Wimblehurst Road Residents Association

Ref: Outline Planning Application DC/25/0629, Former Novartis Site, Parsonage Road, Horsham RH12 5AA.

Proposal: Residential development comprising approximately 206 dwellings, including the conversion of 'Building 3' and the demolition of 'Building 36'. Vehicular access taken from Wimblehurst Road. Car and cycle parking, landscaping and open space and associated works. The replacement of the existing cedar trees at the site.

Stance of response for Outline Planning Application DC/25/0629: Object

Fig. 3 Parsonage Road lane width

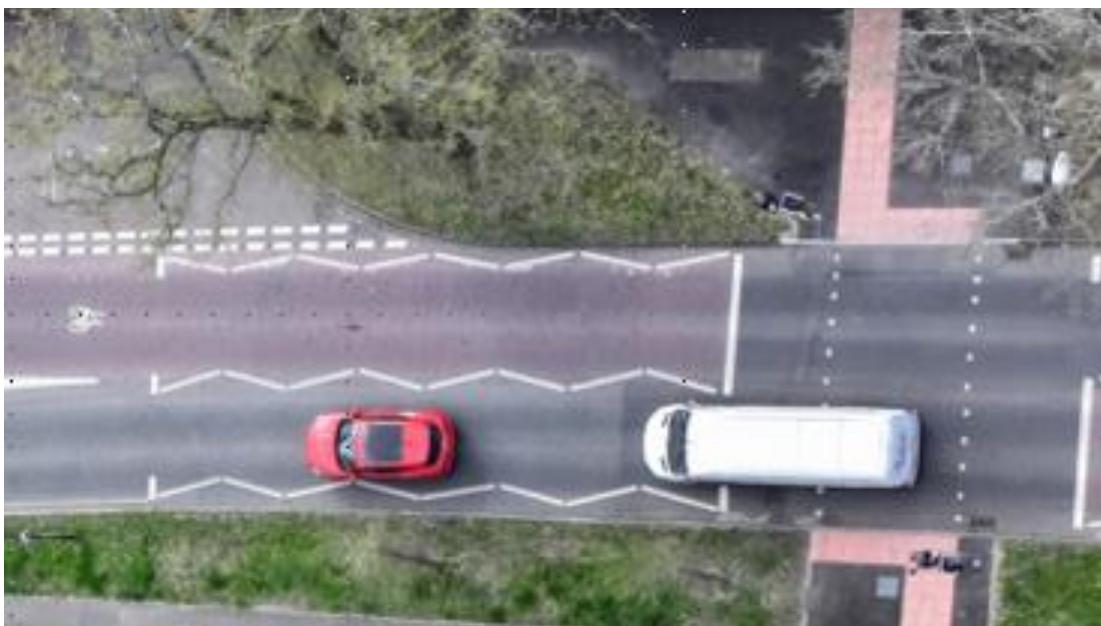
- 2.2.5 Parsonage Road also has very limited space for cyclists in the section from the Wimblehurst Road junction to the proposed Parsonage Road gate. (Fig.3) Cyclists on either side of the closed barriers have to cope with cars accelerating away from the crossing focused only on the road immediately ahead of them, especially if there has been an extended delay at the crossing.

Fig.5 Possible road sign position in Parsonage Road

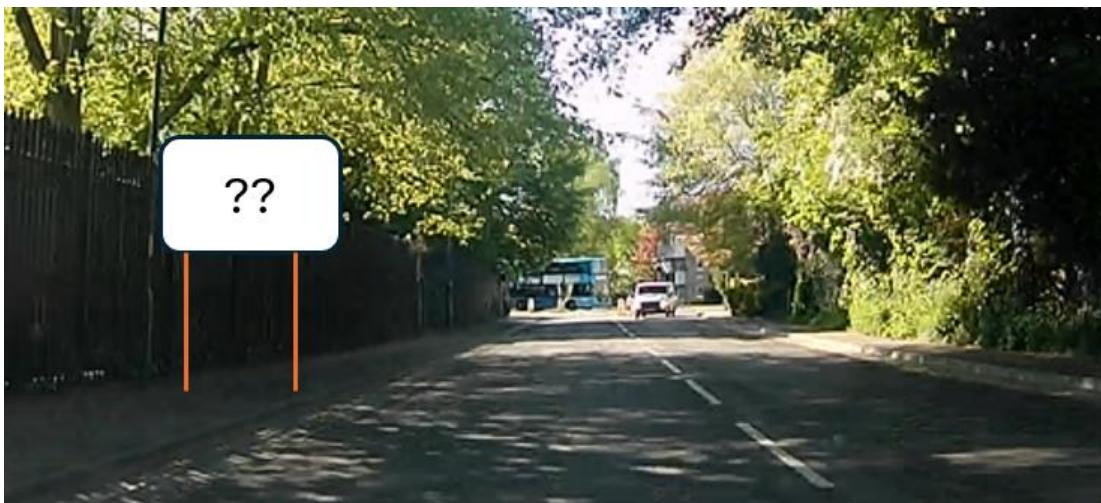
- 2.5.3 Based on drone video footage a car takes just under 2 seconds at 20 mph from the point it is visible by a driver leaving the site, and less for a driver entering the site, though in the latter case the driver will have more visibility of the approaching car. The stopping distance at 20mph is three car lengths. There would just about be enough space to brake safely but only in dry weather conditions. If the road is wet then there is not enough room for the car to come to a safe halt.
- 2.5.4 The second factor is how the junction is going to be presented to a driver approaching the junction along Parsonage Road, especially those with no local knowledge. Unambiguous information on the immediate potential dangers as drivers prepare to bear left at the junction will be an essential element in reducing the risk of collisions and injury.

Fig. 6 Junction schematic from Appendix I

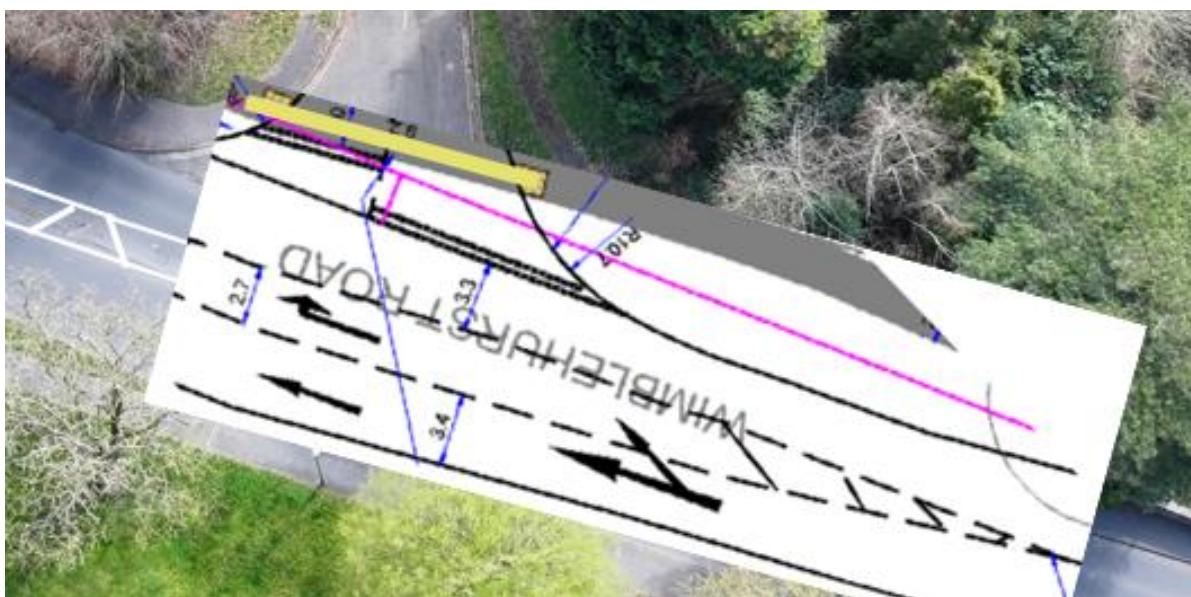
- 2.5.7 The schematic only shows the initial path from the ghost lane into the Wimblehurst gate. There are no arrows representing traffic approaching from the mini-roundabout or from traffic exiting the site. The reality is much more complex and potentially dangerous.
- 2.5.8 No comment is made on potential obstructions to traffic travelling southbound. The relevant schematic of the ghost lane is shown in Fig. 5. Although the schematic has arrows for the northbound traffic there are none for the southbound traffic. The fact that there is traffic approaching from the mini-roundabout and out of the development is therefore not obvious. No reason is given as to why only traffic in a northbound direction is presented.
- 2.5.9 In Fig.7 on the next page a photomontage is presented which indicates the complex array of vehicle movements around the face of the bell mouth access.

- 2.5.15 The overview of traffic paths and conflicts in Fig. 6 above omits the need to accommodate cyclists in Wimblehurst Road, which the developers state is a priority to deliver. In Fig. 9 below the cycle paths are shown in a dark blue dotted line. Going towards the mini-roundabout they may be squeezed for space by vehicles (especially buses and commercial traffic) that have to move over close to the kerb in order to give clearance to the ghost lane.

Fig.7 Traffic path analysis photomontage

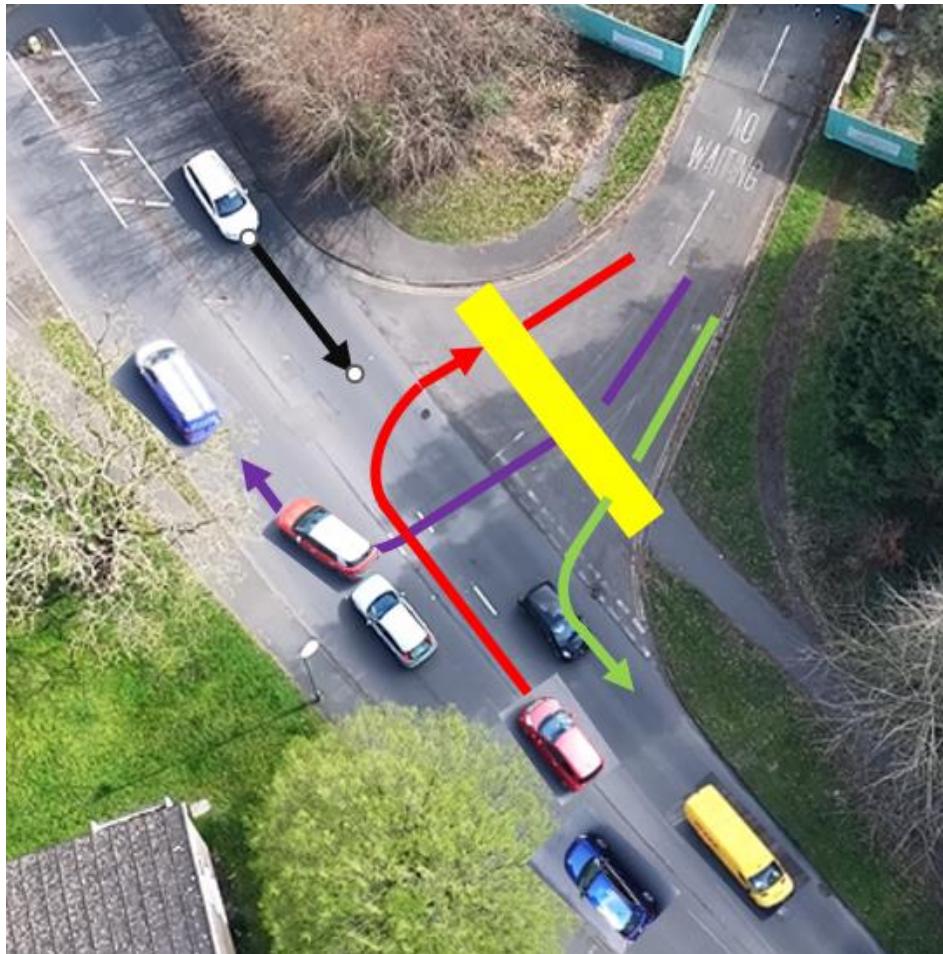
- 2.5.9 The red car is in the ghost lane, planning to turn right into the entrance. However, the driver will have to give way to pedestrians on the Copenhagen crossing (yellow stripe). The white car approaching from the roundabout will not be able to see if there are pedestrians on the crossing and anticipate that the red car may not immediately be able to move off the road. It will not be clear to either of the two drivers who has precedence.

- 2.5.10 The driver of red car with a white roof needs to turn right (46% of exits will do so) and it has to find a slot in traffic approaching the mini-roundabout. Their vision of the oncoming traffic may be partially or totally obscured by the red car in the ghost lane.

Fig. 9 Cycle paths (dotted blue) in Wimblehurst Road

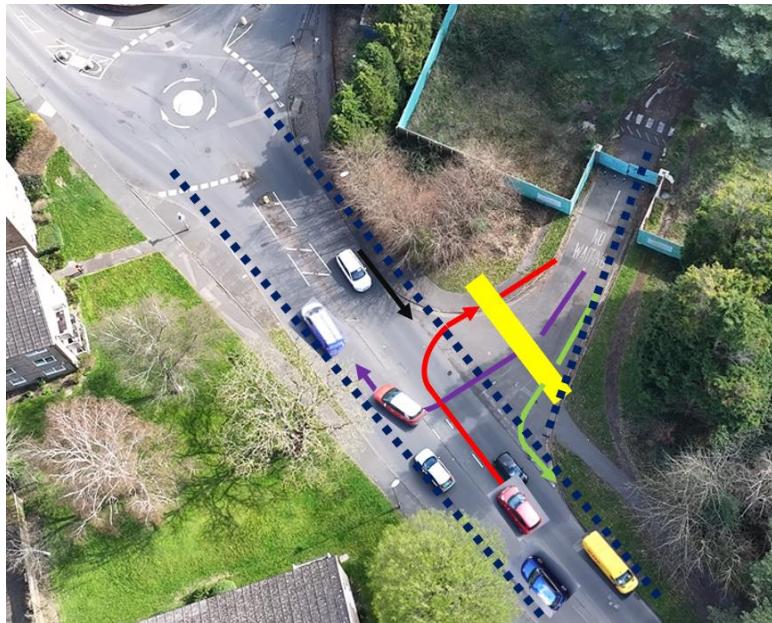
- 2.5.16 Cycling away from the mini-roundabout cyclists have traffic approaching them (out of vision) from both Parsonage Road and North Heath Lane and as they approach

the Wimblehurst Road access they are faced with traffic moving across in both directions.

2.5.17 All this is taking place in this small area of road.

Fig. 18 Proposed pedestrian crossing at Richmond Road

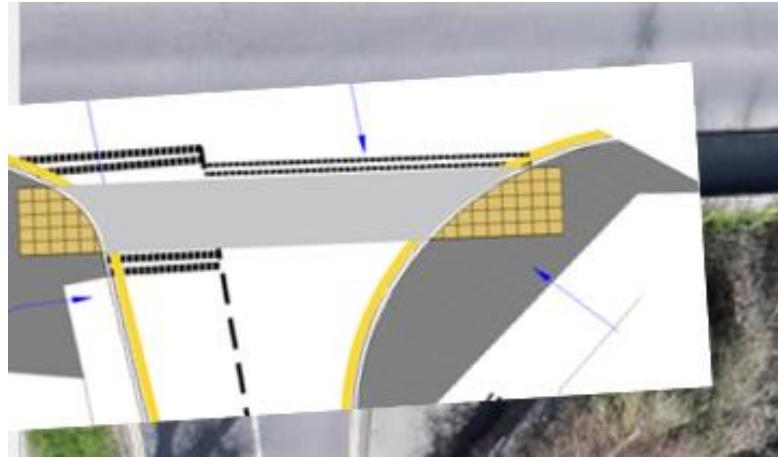
- 2.5.28 The Application proposes that a pedestrian priority traverse is installed at this junction. The design is shown below in which the schematic from Appendix I has been overlaid on a drone photograph.

- 2.5.29 This is not a solution to the safety of pedestrians. The vast majority of pedestrians walking over the railway bridge towards the Richmond Road junction are planning to walk down Richmond Road itself. There is no reason for them to walk on down Wimblehurst Road other than to access one of the houses.
- 2.5.30 These pedestrians take a short cut across the road to the opposite side as there is no pavement on the northern kerb. A pedestrian can be seen in Fig. 19.

Fig. 19 Pedestrian route across Richmond Road.

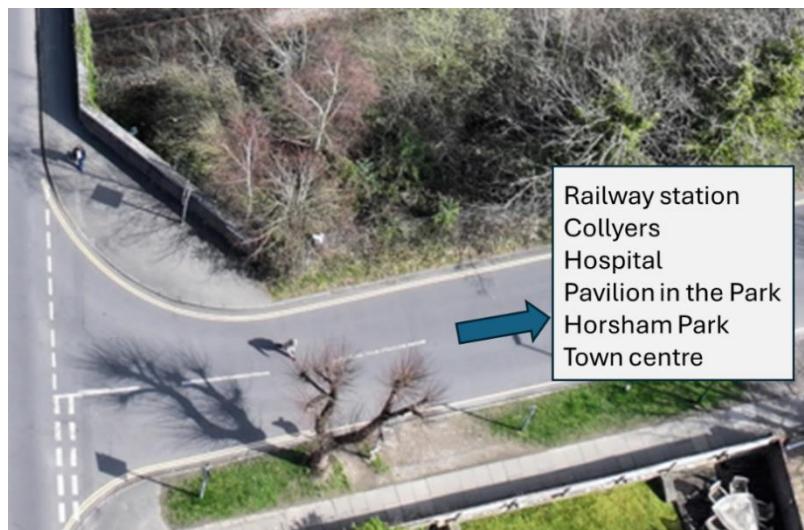
- 2.5.31 If there are one or more cars waiting to exit into Wimblehurst Road in either direction a pedestrian can see traffic slowly approaching and walk behind the stationary car with a high degree of safety. There are of course cars coming around the corner from the railway bridge but the corner is very tight and that gives just enough extra time to be aware of pedestrians crossing the road at an angle.

Fig. 1 Aerial view of the Boulevard

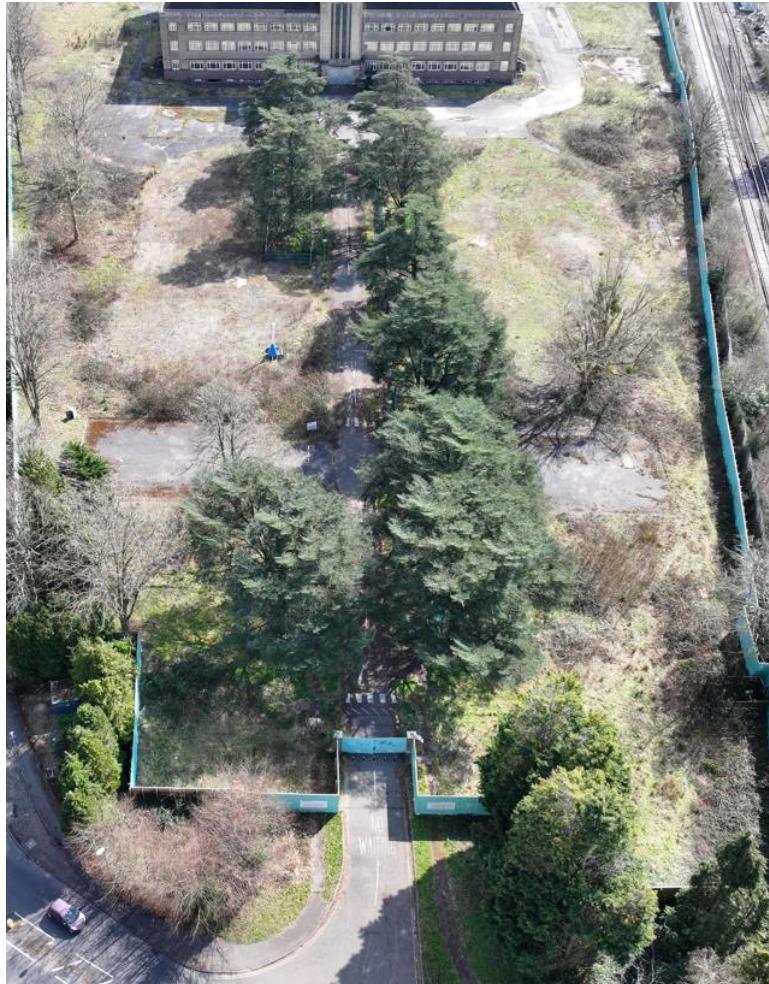
- 4.3.9 The Application request is for planning permission for ‘the Replacement of the existing cedar trees at the site’. However, despite all drawings/sketches showing trees along the Boulevard, the Biodiversity Net Gain Assessment document, dated 21/3/2025, shows on p32 a map, and there are no trees depicted for the Boulevard,
